**RE: PROPOSED RECONFIGURING A LOT
AT 53 EVELYN ROAD IN WYNNUM WEST
COUNCIL REFERENCE NUMBER A006900130**

We refer to the above application and Council's Further Advice letter dated 02 July 2026. Please find below a response to the items raised in these requests:

Previously proposed and updated proposed subdivision plans

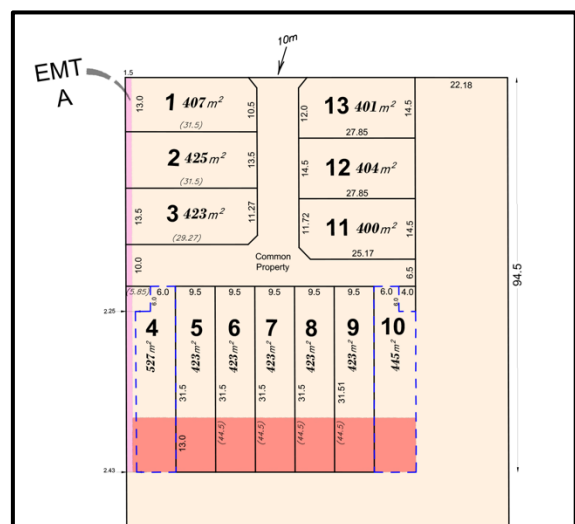
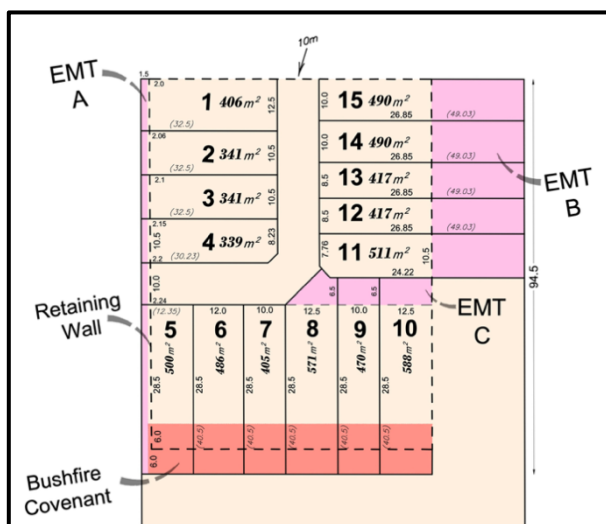
In response to items 1(a), 2(a), and 3(a) of Council's request, we confirm the following amendments were made to the proposal plan:

- Increase the minimum lot sizes from 339sqm to 400sqm, with the majority of lots a minimum of 423sqm, and
- Convert Easements B and C to common property.

Please refer to the before and after images below for confirmation of these changes.
